SAN FRANCISCO PLANNING DEPARTMENT

MEMO

RE: **Review and Comment: 200 Larkin Street (Asian Art Museum)**
Case No. 2016-007523COA

Hyde Street Elevation, Proposed

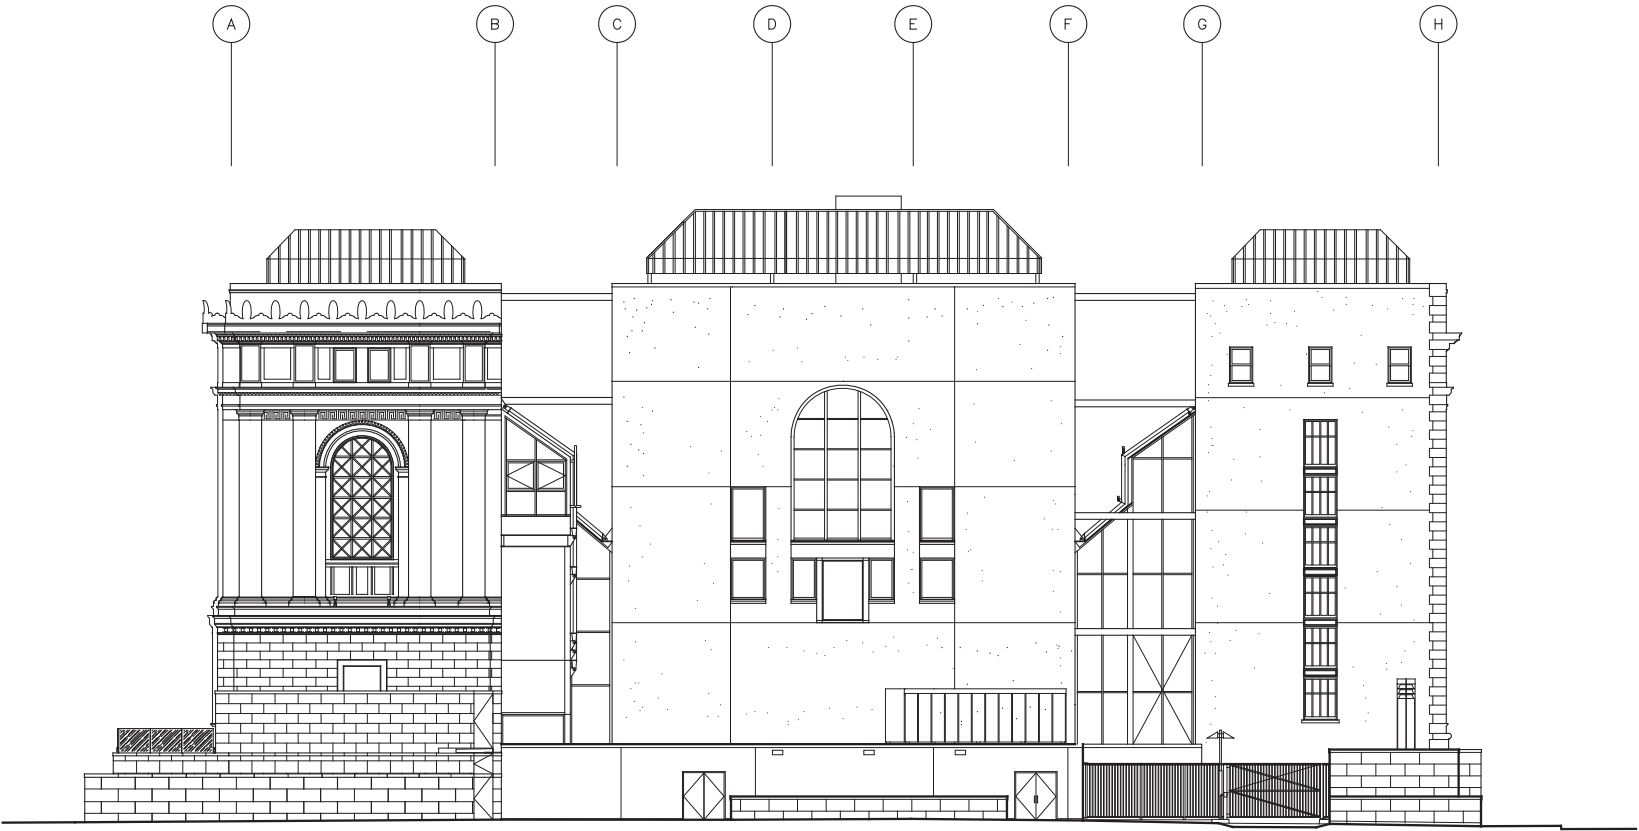
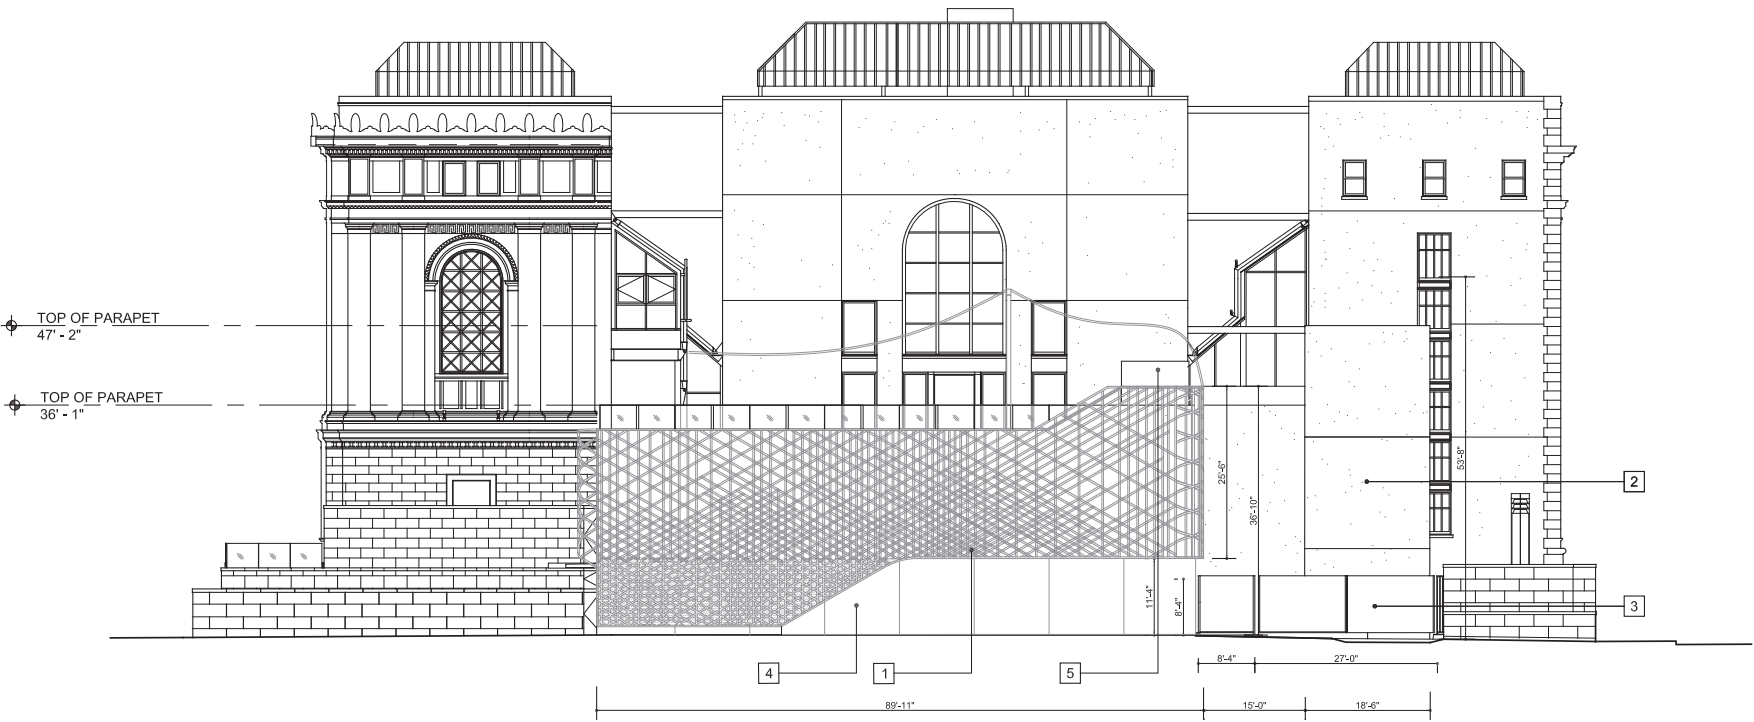
The project, which proposes a vertical addition above an existing shear wall, includes a large span of ground floor glazing on the Hyde Street elevation to introduce a window-like condition where currently a solid concrete shear wall exists. The addition, which will be used as an art gallery, does not propose to have any daylighting into the building. An exterior lighting plan is proposed for the areas of the building that would be clad in the ornamental metal screen. The Project Sponsor has provided alternative designs for the ground floor shear wall, which propose a series of smaller glazed vitrines along the concrete wall versus continuous glazing along Hyde Street. In

For the upper, double-height story, the Department recommends treating the cladding in a manner that provides additional perceived depth and changes in the façade plane that reinforce the regularized treatment of building fenestration on civic buildings within the landmark district.

The Department recommends refinement of the exterior cladding on the vertical addition to create more depth of plane, perhaps taking cues from fenestration patterns on the main building, the Federal Building across Hyde Street, and other contributing buildings in the district. The Project Sponsor might explore modulation of the façade through the incorporation of elements such as deep recesses or punched openings in the screen, or the creation of a secondary layer in the patterning of the screen through changes in the cladding's material and/or finish. For reference, the Project Sponsor should review the 1987 report, "The San Francisco Civic Center: A Study in Urban Form." This report contains many measurements and calculations of elements of the façade such as the height ranges of horizontal zones, the depth of voids in the façade and the percentage of openings of the whole planar surface. In designing a building, reference should be made

Guardrail design studies

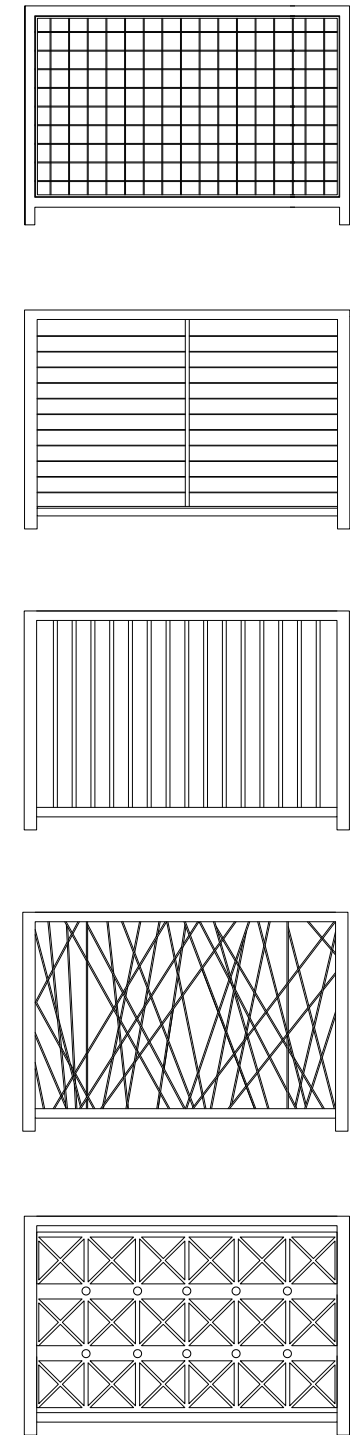
Publicly visible glass railings at roof parapets are not compatible and/or characteristic of the surrounding district and add a reflective material on the exterior. The Department recommends extending the exterior cladding material up to a height above the roof that matches a safety railing height, or exploring a greater setback of the safety railing to a point on the roof where it is no longer publicly visible.
